**Before the
FEDERAL COMMUNICATIONS COMMISSION
Washington, D.C. 20554**

In the matter of)	
)	
)	
Space Exploration Holdings, LLC)	File No. SAT-MOD-20200417-00037
)	Call Signs: S2983/3018
Application for Modification of)	
Authorization for the SpaceX)	
NGSO Satellite System)

COMMENTS OF ONEWEB

COMMENTS OF ONEWEB

**Figure A – Interference statistics (I/N) for SpaceX downlink into OneWeb Receive Gateway Earth Station
(Modified SpaceX System PFD = -126 dBW/m²/MHz)**

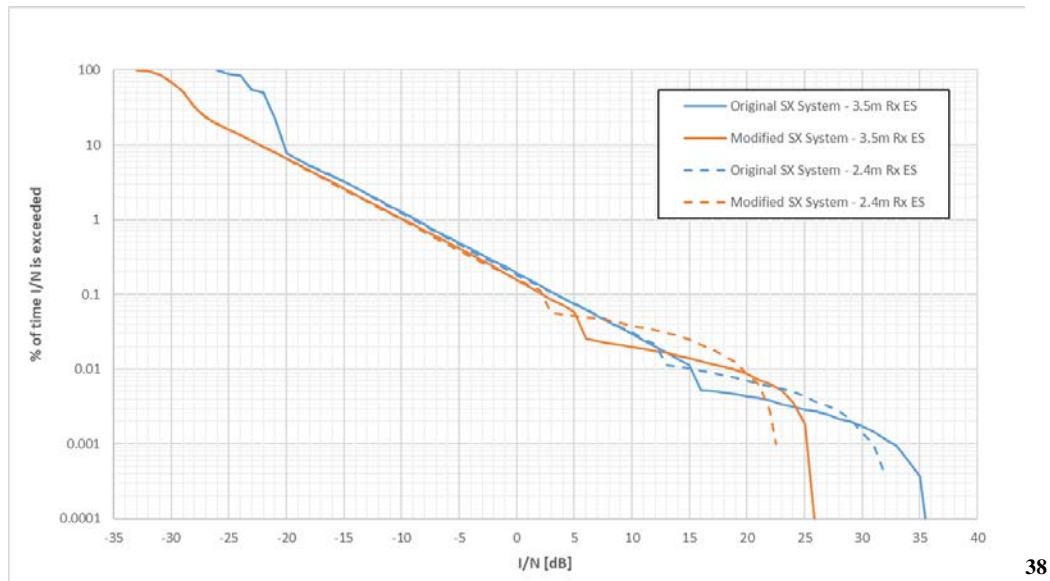
The Cumulative Distribution Functions (“CDF”)—which indicate the probability that a given value is exceeded—of the I/N experienced by OneWeb’s gateway earth station receive antennas are illustrated in Figure A below. Results for OneWeb earth station antennas of both 2.4m and 3.5m are presented.

Figure A demonstrates that the decrease in minimum elevation angle of SpaceX’s gateway earth stations—a consequence of lowering SpaceX’s system orbit altitude—and the increase in the number of satellites transmitting to a SpaceX gateway would result in a degraded interference environment (*i.e.* the curves for the Third SpaceX Modification are wider), had it not been for the severe decrease in SpaceX’s PFD (*i.e.* the curves for the Third SpaceX Modification are shifted 10 dB to the left). Given the inconsistency in PFD levels explained above, OneWeb also performed these dynamic simulations with a PFD for the Third SpaceX Modification of -123 dBW/m²/MHz, a reduction of 7 dB from the PFD stated in the SpaceX 2016 License Application consistent with the results of the analysis in the Third SpaceX Modification using the Telesat and O3b systems:

Figure B – Interference statistics (I/N) for SpaceX downlink into OneWeb Receive Gateway Earth Station
(Modified SpaceX System PFD = -123 dBW/m²/MHz)

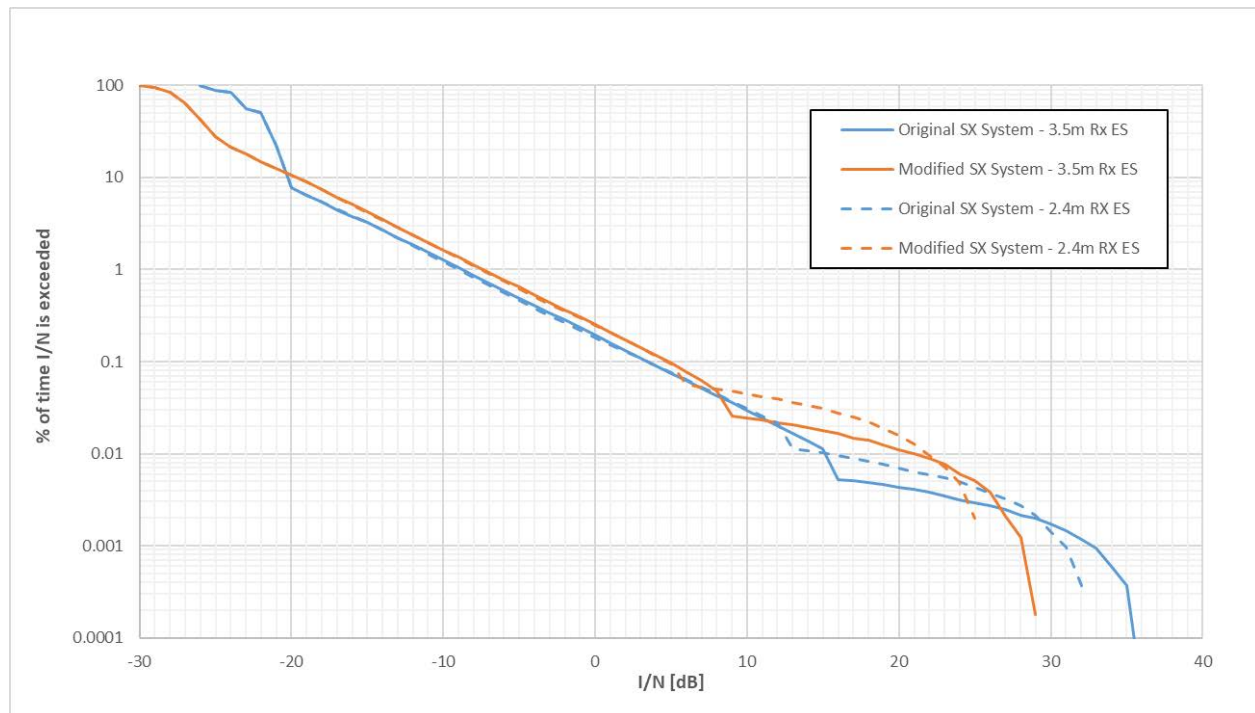
As demonstrated in Figure B, if the downlink PFD of the SpaceX satellites is reduced by 7 dB instead of 10 dB, the Third SpaceX Modification will increase the interference experienced by a OneWeb gateway earth station receiver in Ka-band for wide ranges of I/N values. In the case of an I/N value of -12.2 dB,³⁹ the percentage of time (*i.e.*, the period during which the I/N exceeds -12.2 dB) increases by *approximately 30 percent* for both the 2.4m and 3.5m gateway receive antennas as a result of the Third SpaceX Modification. Even for higher I/N values up to +5 dB, there is a similar increase in the percentage of time.⁴⁰ Thus, the foregoing analysis demonstrates

that the Third SpaceX Modification has the potential to cause significant negative impacts to the downlink operations of OneWeb's gateway earth stations in the Ka-band.

**Figure C – Interference statistics (I/N) for OneWeb downlink into SpaceX Rx ES
(Tracking strategy: "longest pass")**

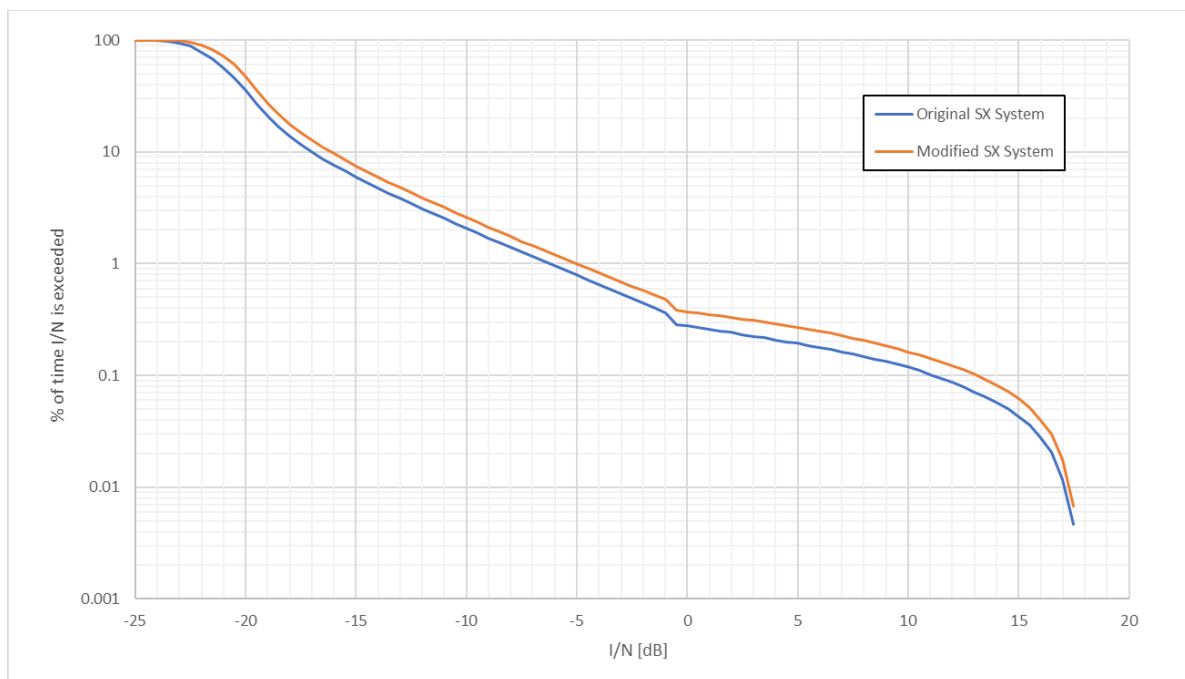
The first set of results presented below are the I/N statistics, which are calculated without considering a reduction in the SpaceX downlink PFD and demonstrate the degradation of the interference environment resulting from the reduction in minimum elevation angle of SpaceX's gateway earth stations. The I/N CDF for one of the SpaceX downlinks is presented in Figure C for the "longest pass" tracking strategy, and Figure D for the "highest elevation" tracking strategy.

Figures C and D above demonstrate that a grant of the Third SpaceX Modification could result in increased OneWeb downlink interference into the SpaceX receiving earth stations, irrespective of the tracking strategy selected. In the above-referenced case, the interference is worse for all I/N values. In the case of an I/N value of -12.2 dB, the percentage of time increases by *25 percent* when considering a “longest pass” tracking strategy and by *140 percent* with a “highest elevation” tracking strategy.

**Figure E – Interference statistics (C/I) for OneWeb downlink into SpaceX Rx ES
(Tracking strategy: “longest pass”)**

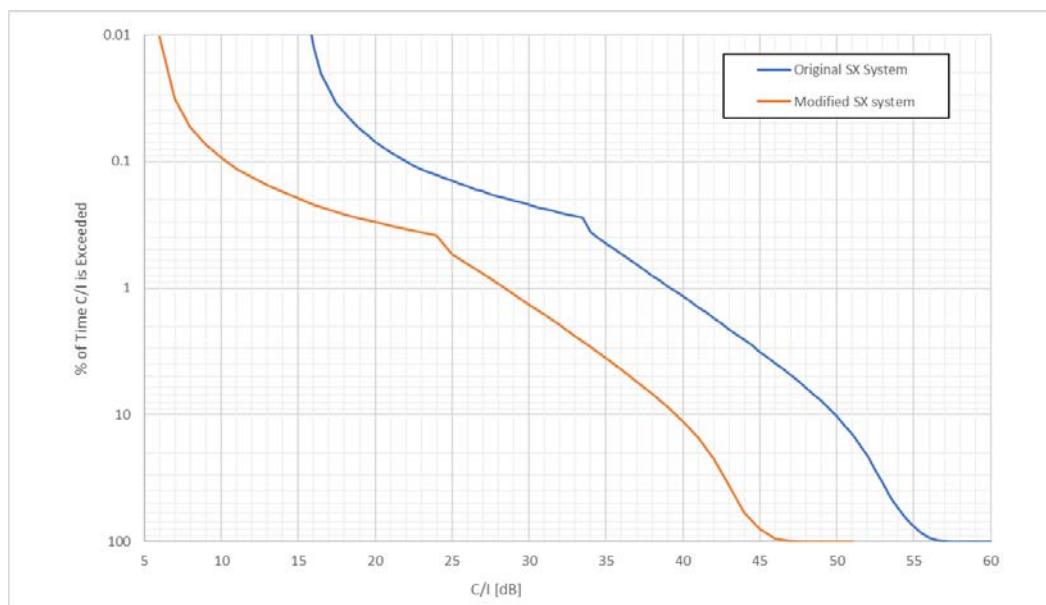
The negative effects of the Third SpaceX Modification experienced in the Ka-band operations of other NGSO systems is even more apparent when the reduction in the SpaceX downlink PFD is also taken into account. The increased interference susceptibility of SpaceX’s gateway operations as a result of the reduction in downlink PFD can be assessed by analyzing the Carrier-to-Interfering Signal Power Ratio (“C/I”) experienced by SpaceX’s earth station receivers. Figure E below shows the C/I CDFs obtained in the simulation described above. These results

Figure E demonstrates that the SpaceX gateway receiving earth stations will experience significantly lower C/I levels as a result of the combination of the lower altitude orbits and the 10 dB reduction in PFD at the Earth’s surface. In the SpaceX system proposed in the SpaceX 2016 License Application (blue line), the C/I experienced by the SpaceX gateway receivers was never below 16 dB, which is a level that should be quite tolerable for small amounts of time for modern satellite networks employing adaptive coding and modulation. However, as a result of the Third SpaceX Modification, the SpaceX system would experience a C/I as low as 6 dB (as shown in the orange line above), representing a significantly worse interference event that carries serious operational consequences. Consequently, OneWeb anticipates that SpaceX may request certain mitigation measures from other NGSO operators to protect its gateway receiving earth stations in

the Ka-band as a result of the proposed Third SpaceX Modification. In other words, OneWeb (and potentially other NGSO FSS operators in the Ka-band) could be unjustly forced to shoulder more stringent operational conditions as a result of any grant of the Third SpaceX Modification.

Therefore, the Commission must condition any grant of the Third SpaceX Modification such that SpaceX must not request additional protection for its Ka-band gateways as a result of the decrease in its Ka-band downlink PFD. Such a condition would protect the operations of OneWeb and other NGSO operators and also align consideration of the Third SpaceX Modification with prior Commission grants of SpaceX modification applications resulting in greater SpaceX susceptibility to interference.⁴⁶

Figure F – Interference statistics (C/I) for OneWeb uplink into SpaceX Rx satellite (Tracking strategy: “longest pass”)

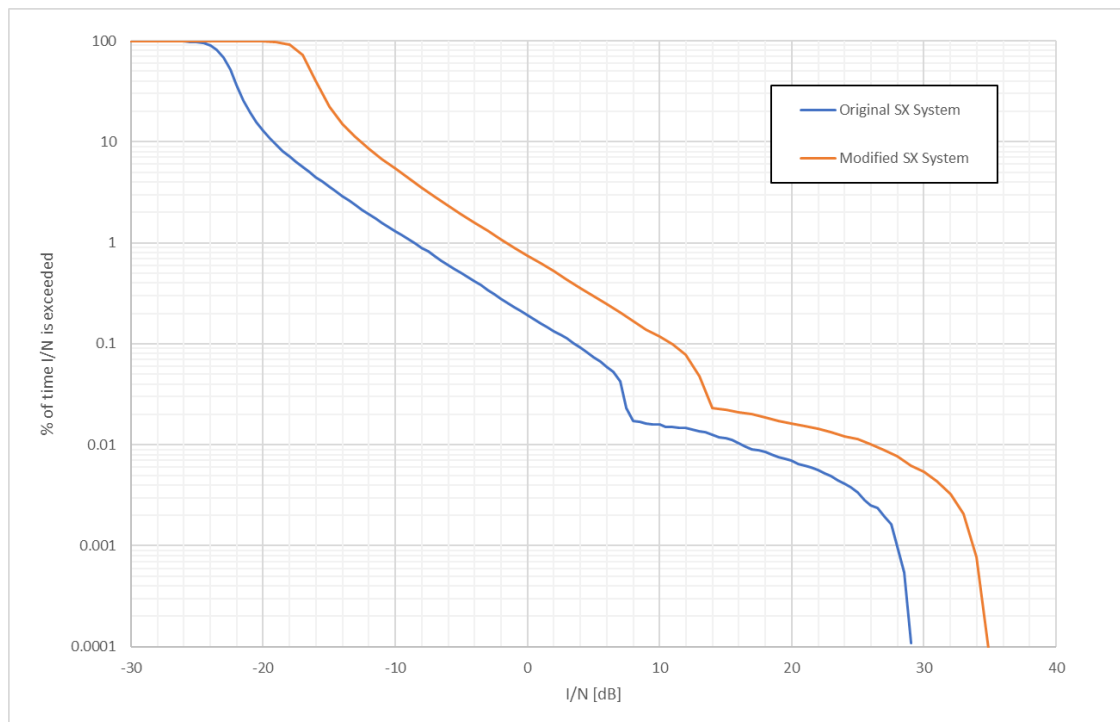
The CDF of the I/N experienced by a SpaceX gateway uplink signal in the original and modified systems are presented in Figure F.

These results unequivocally demonstrate that grant of the Third SpaceX Modification will result in SpaceX's Ka-band satellite receivers experiencing higher levels of interference. Note that the percentage of time the Commission's -12.2 dB I/N coordination trigger is exceeded increases from about two percent to about 8.5 percent, more than tripling the likelihood of such events. In the absence of successful coordination to resolve this scenario, band splitting would be required pursuant to the Commission's rules.⁴⁷ A similar result exists for almost any viable level of I/N that might be agreed upon between co-frequency NGSO operators during inter-operator coordination due to the very similar shape of the two curves in Figure F. Consequently, this outcome could result in SpaceX seeking more stringent operational conditions on OneWeb and other authorized Ka-band operators than those that would have otherwise been required for the system proposed in the SpaceX 2016 License Application.

Figure G – Interference statistics (I/N) for OneWeb uplink into SpaceX Satellite Receiver

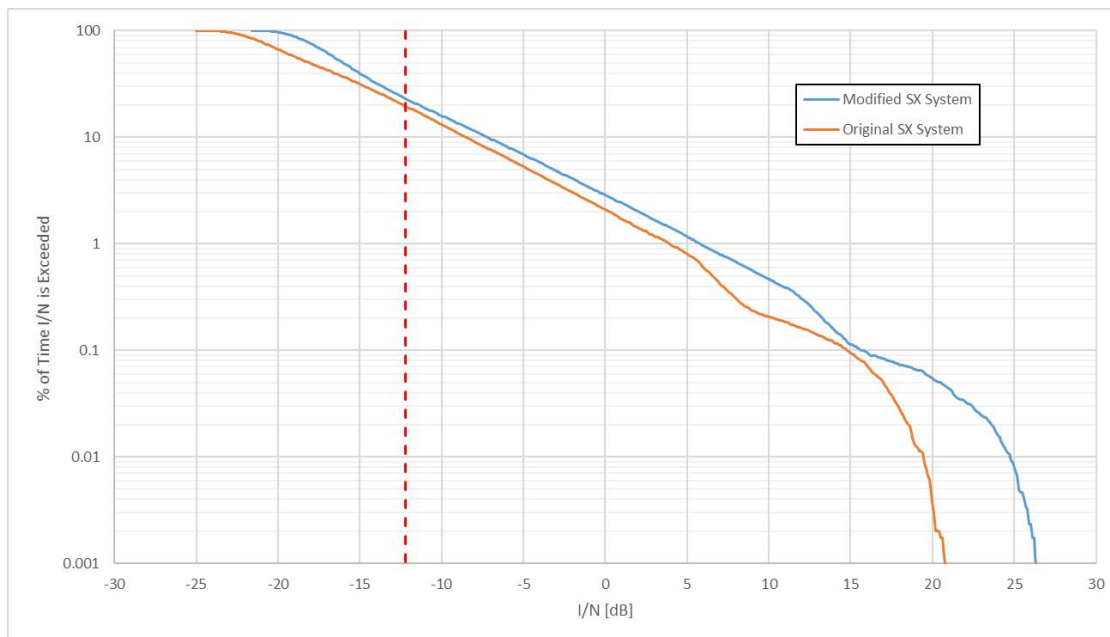
The CDF of the I/N experienced by a SpaceX Ku-band satellite receiver in the original and modified SpaceX systems are shown in Figure G.

At the short-term end of the CDF curve (*i.e.*, the highest levels of interference for the shortest percentage of time) the difference in interference between the two curves is approximately 6 dB and is accounted for by the reduced path length and path loss to the SpaceX satellites. However, Figure G demonstrates that the proposed Third SpaceX Modification will increase the interference experienced by the SpaceX Ku-band satellite receivers *for all percentages of time* on the CDF curve.

Regardless of the basis for this erroneous conclusion, OneWeb emphasizes that the performance of the fully modified SpaceX system is of critical importance. As demonstrated in Figure G above, the uplink interference into SpaceX from the transmitting earth stations of other Ku-band NGSO systems is increased by the proposed Third SpaceX Modification. Simply put, if this potential interference susceptibility increase is not remediated by the Commission in any grant of the Third SpaceX Modification, then other NGSO operators will be unfairly burdened with resolving interference issues which have been generated as a result of the Third SpaceX Modification. Additionally, in the absence of a coordination agreement between other NGSO operators and SpaceX, the total time that a user terminal would experience an in-line interference event—and during which band-splitting could be required—would increase, resulting in additional burdens for other NGSO operators.

Therefore, OneWeb restates its request that the Commission condition grant of the Third SpaceX Modification such that SpaceX accept any additional interference caused by its orbit altitude modification. Such an outcome would (1) ensure that other NGSO operators are not unfairly required to provide additional interference protection to SpaceX, (2) incentivize the efficient utilization of spectrum resources and (3) appropriately place the burden for addressing these increased interference events on SpaceX.
